WORK PLAN ADDENDUM FOR OFFSITE WELLS IN THE SOUTH PLUME AREA

**DOE-336-90
DOE-FN USEPA
5
ADDENDUM**

RI/FS DOCUMENT CHANGE REQUEST

FIGURE 1

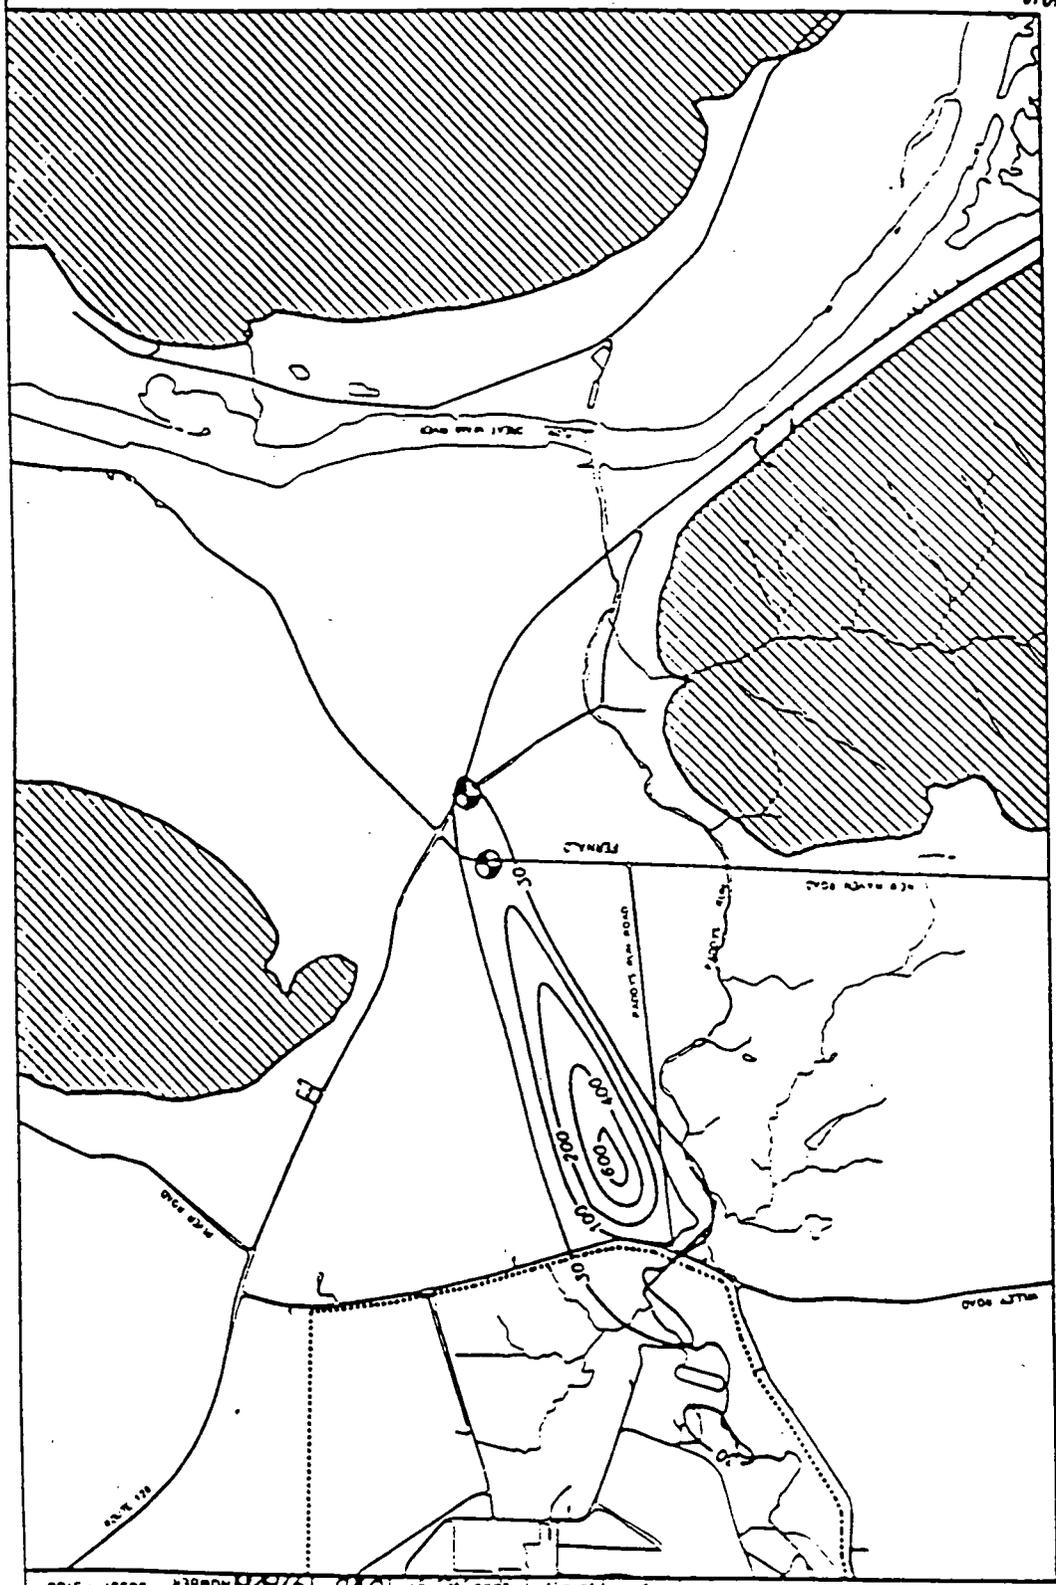
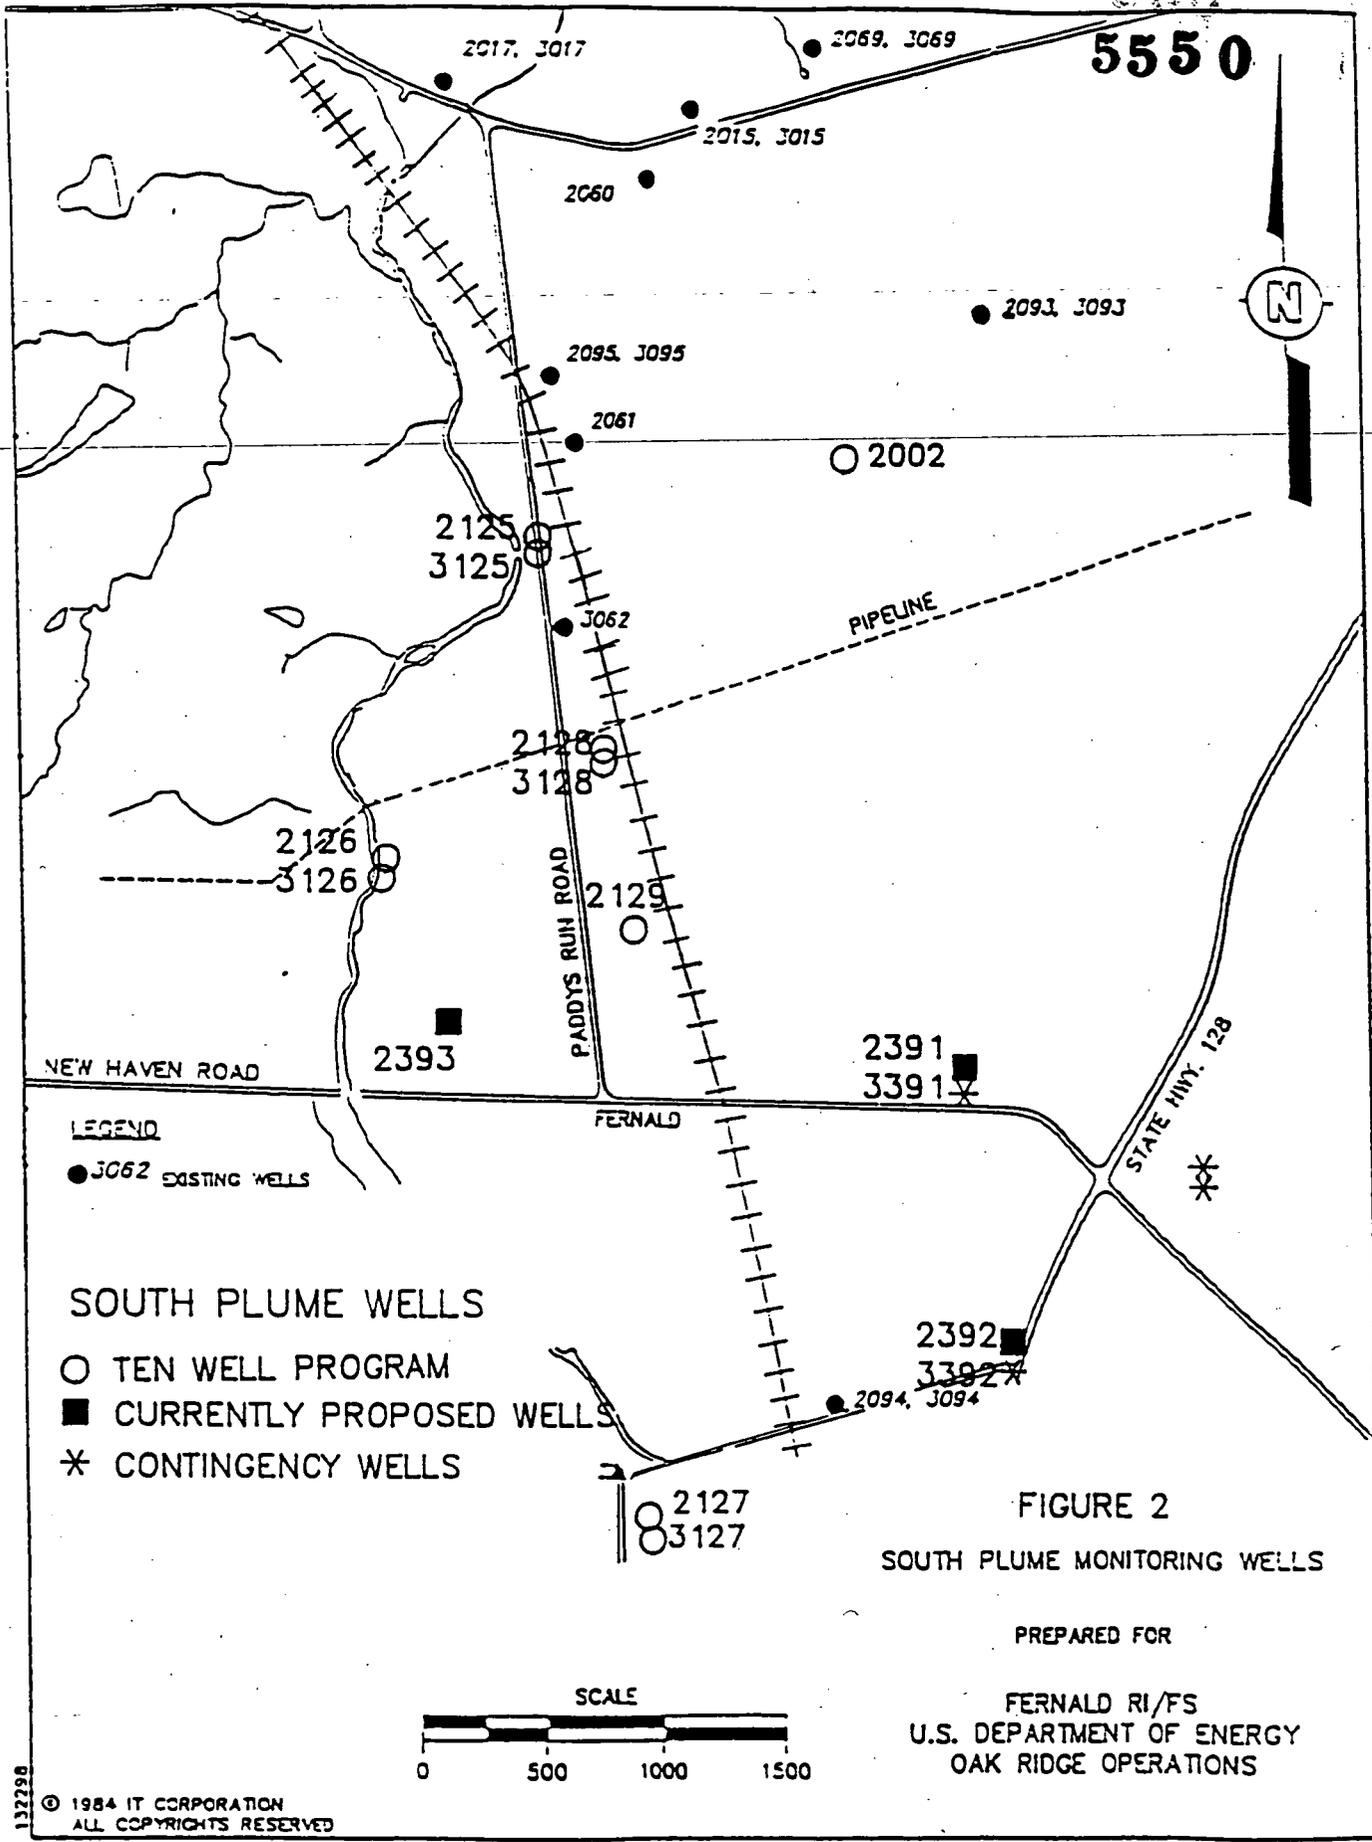
Current model interpretations indicate that the main plume has a long slender shape and that it extends a considerable distance to the southeast as shown in Figure 1. The location of the southern third of the plume is farther to the east beyond current monitoring wells. Figure 2 shows the locations of proposed wells 2391 and 2392 which will refine the definition of the South Plume and determine if the model prediction of the southern tip of the South Plume is accurate. The appearance of 4.5 ug/l uranium in existing well 2094 in January 1988, while not a high value, indicates that uranium is present in the area.
